**Re: Kelly's Liquor—Ventana Ranch, 6531 Paradise Blvd. NW,
Request for Permanent C.O.—Approved
Engineer's Stamp dated: 06-03-09, (B-10/D003C2)
Certification dated: 8-12-10**

VENTANA RANCH KELLY LIQUORS

GRADING AND DRAINAGE PLAN

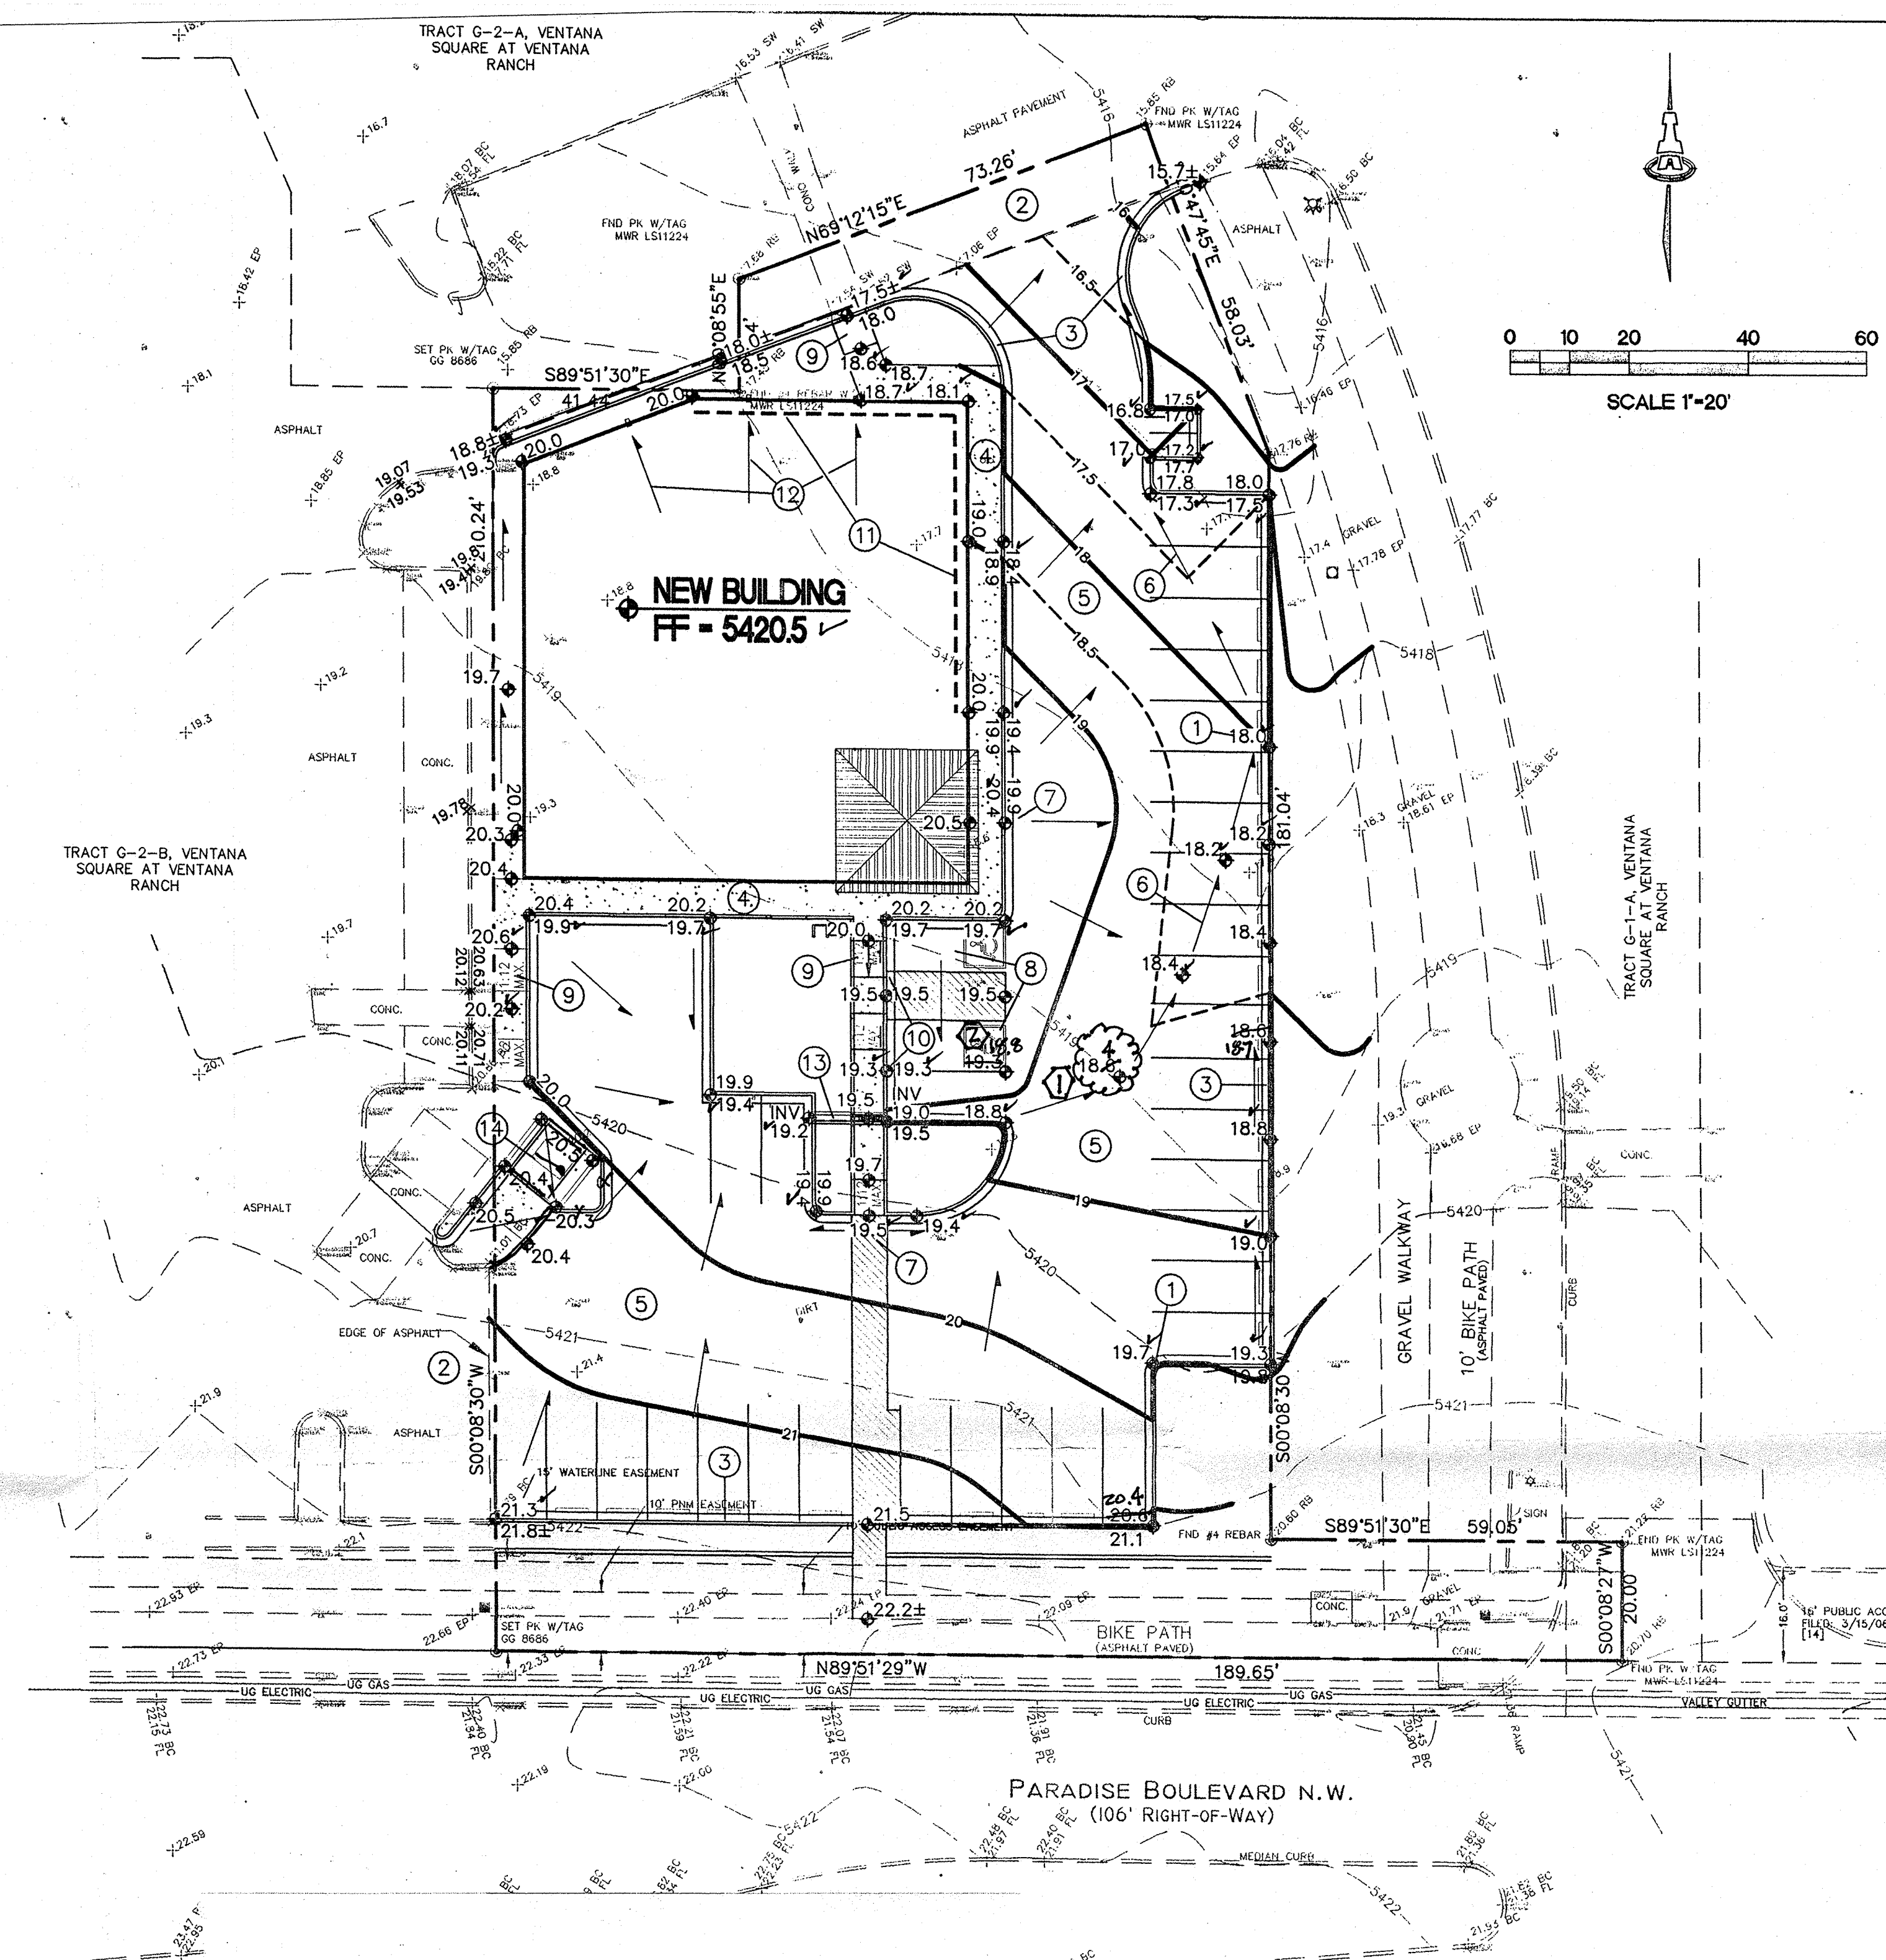
DEFICIENCIES:

- The low point in the asphalt swale in the easterly drive isle must be raised to prevent ponding of storm waters.
- The southeast corner of the handicapped parking must be raised to a grade of 18.9 to satisfy the 2% cross-slope maximum allowable per ADA.
